Product change information (PCN)

PCN No.:	AAC170025	Date:	23.05.2018
Product:	MKDSO 2,5/ 2- and 4-pos.

Previous production status	New production status

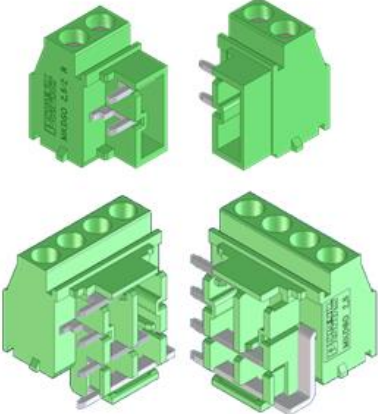
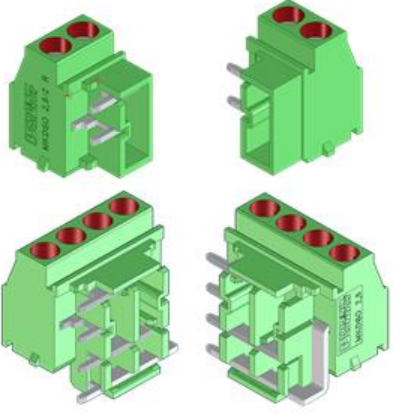
Description of changes		
<input checked="" type="checkbox"/> Product appearance (fit)	<input type="checkbox"/> Product geometry (form)	<input type="checkbox"/> Product function (function)
Screw brakes (marked in red)		
A screw brake is added so that the screw has a firmer hold in the screw shaft. The clamping space will then definitely stay open.
